Memo

To: Gary Wert
From: Jeff Walton, Associate Planner; 910-341-3260
CC: File;
Date: 3/14/2016
Re: Ogden Marketplace Planning Comments

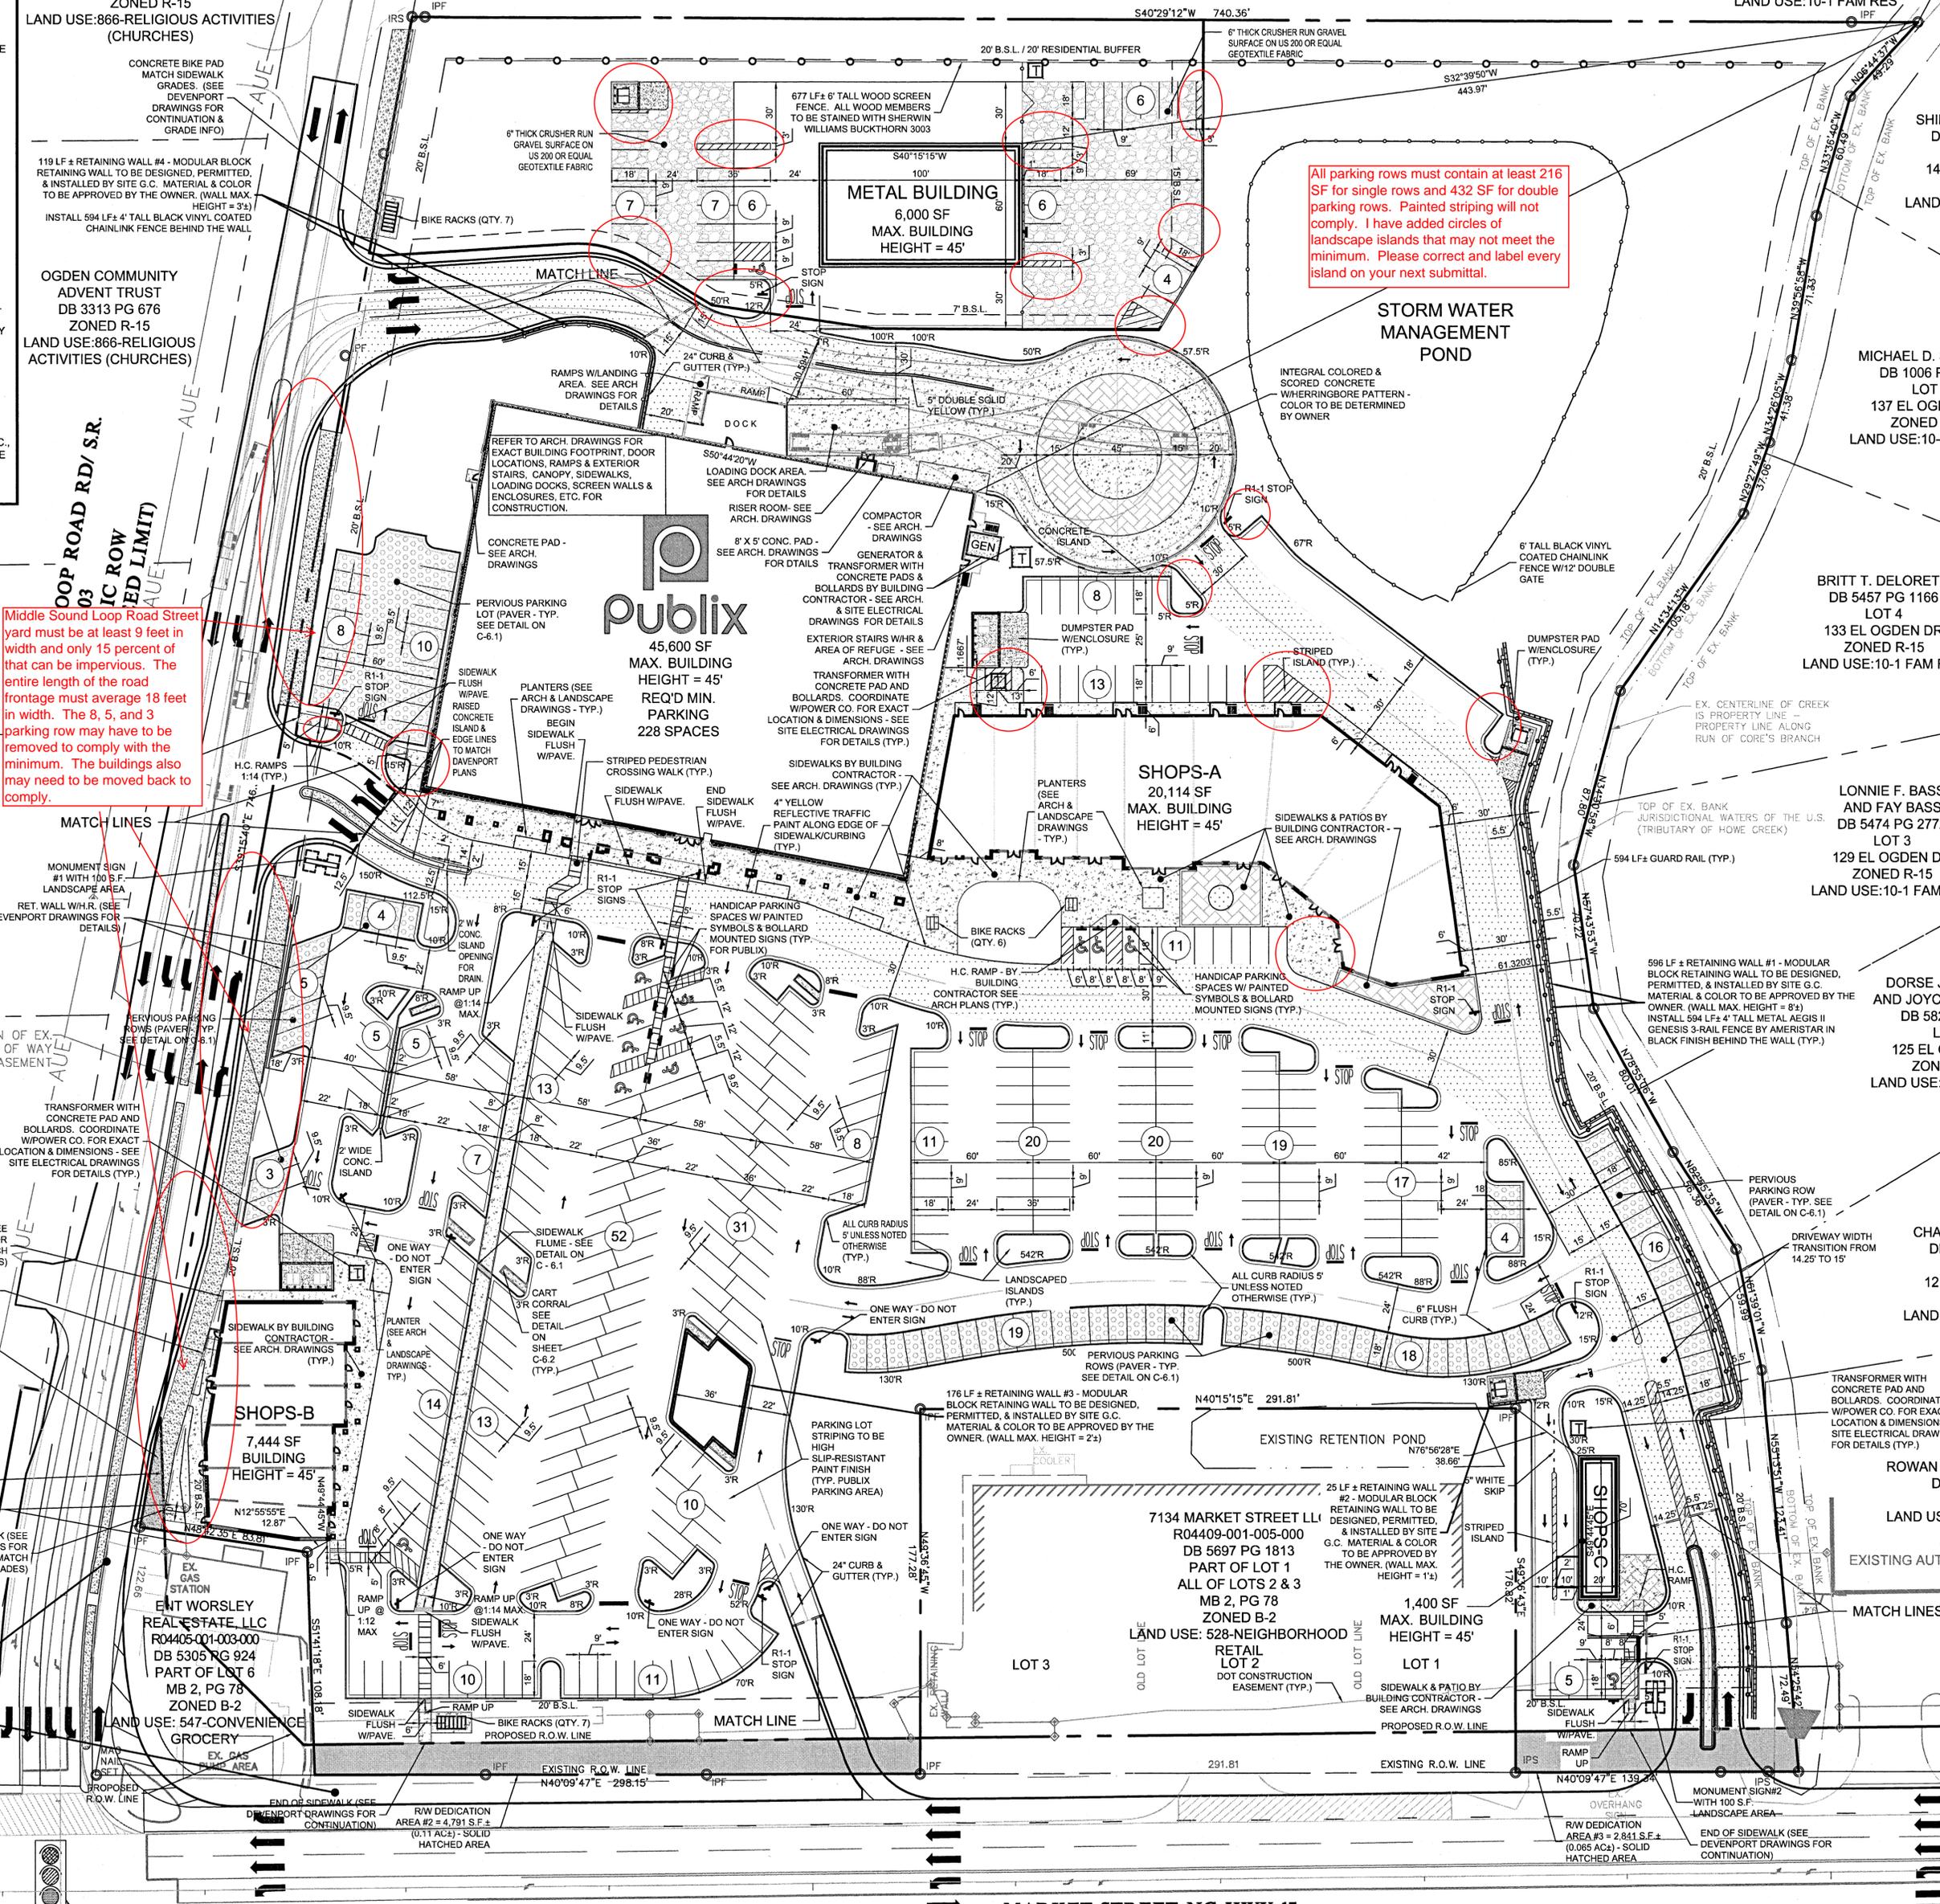
Middle Sound Loop Road Street yard must be at least 9 feet in width and only 15 percent of that can be impervious. The entire length of the road frontage must average 18 feet in width. The 8, 5, and 3 parking row may have to be removed to comply with the minimum. The buildings also may need to be moved back to comply.

All parking rows must contain at least 216 SF for single rows and 432 SF for double parking rows. Painted striping will not comply. I have added circles of landscape islands that may not meet the minimum. Please correct and label every island on your next submittal.
